## ASSESSMENT REPORT

### Section 75W Modification Spring Farm Resource Recovery Park

**Figure 5** – 2 Odour Unit isopleth for predicted cumulative odour impacts.

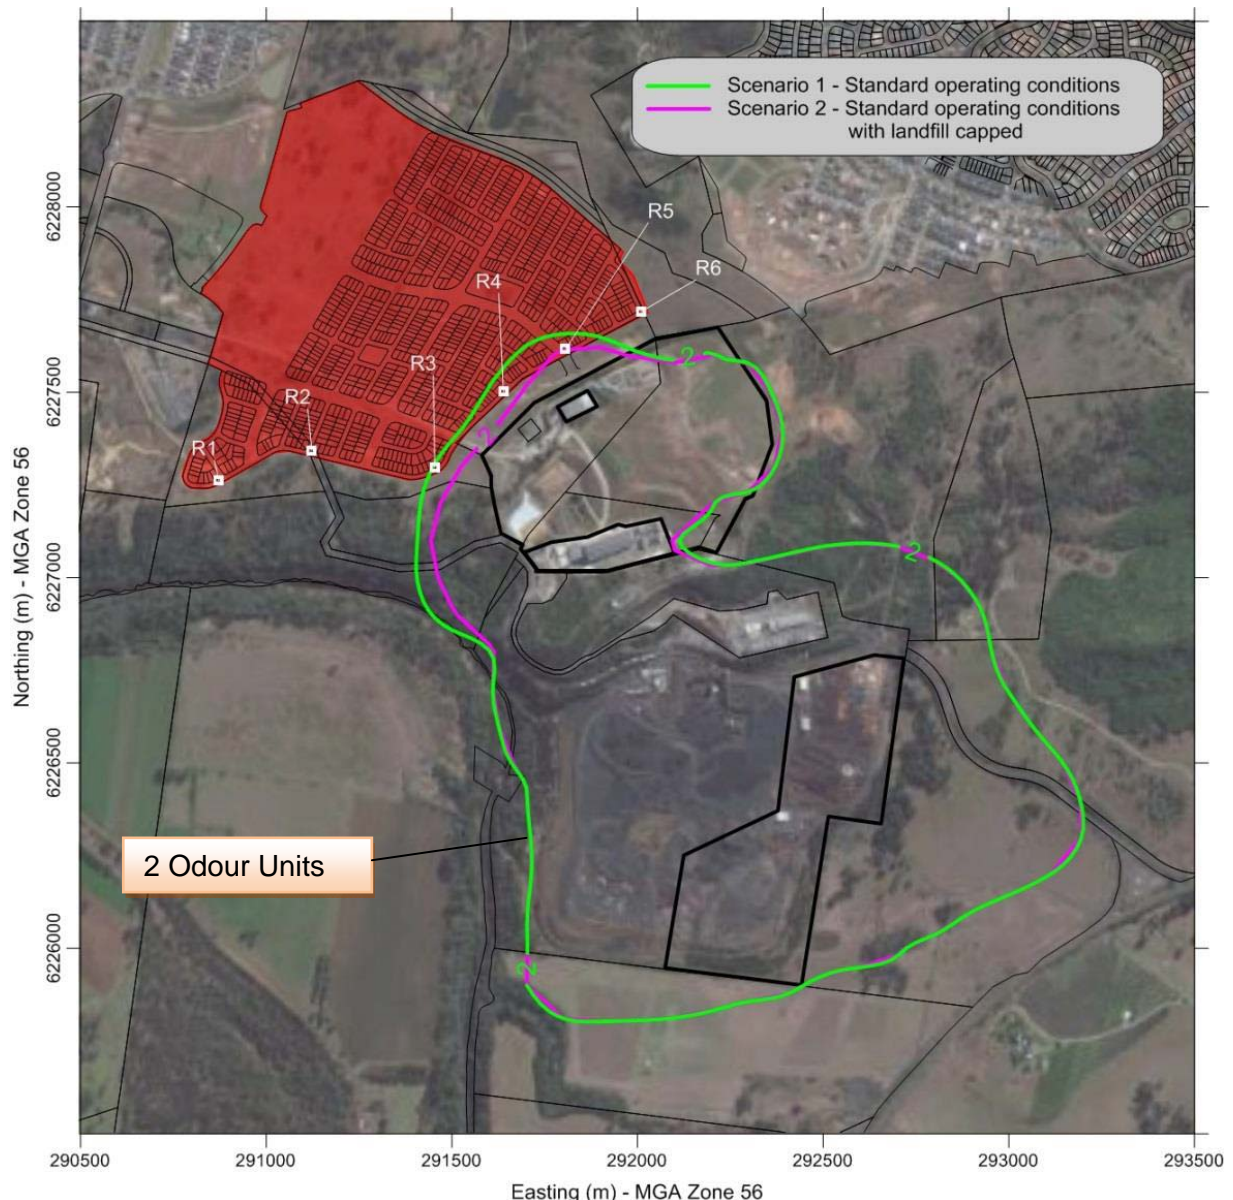
The modelled cumulative odour impacts demonstrated that two Odour Units (OUs) would not be exceeded at the nearest residential receivers. These predictions comply with the lowest criteria specified in the EPA's *Approved Methods for Modelling and Assessment of Air Pollutants in NSW*. A contour for two OUs is shown in **Figure 5**.

In interpreting **Figure 5**, it is important to note that the odour contour is applied to the map using an algorithm that smooths the contour between predictions at a range of representative receivers. However, for assessment purposes, the individual predictions are rounded to the nearest whole number. Therefore, while the green contour in **Figure 5** extends to future residential areas, indicating odour impacts in fractions above two OUs, the impacts at these receivers, according to the *Approved Methods* are regarded as two OUs.

In any case, once the landfill ceases to operate in 2017, the two OU contour moves to the east away from the future residential area, as indicated by the pink contour in **Figure 5**.
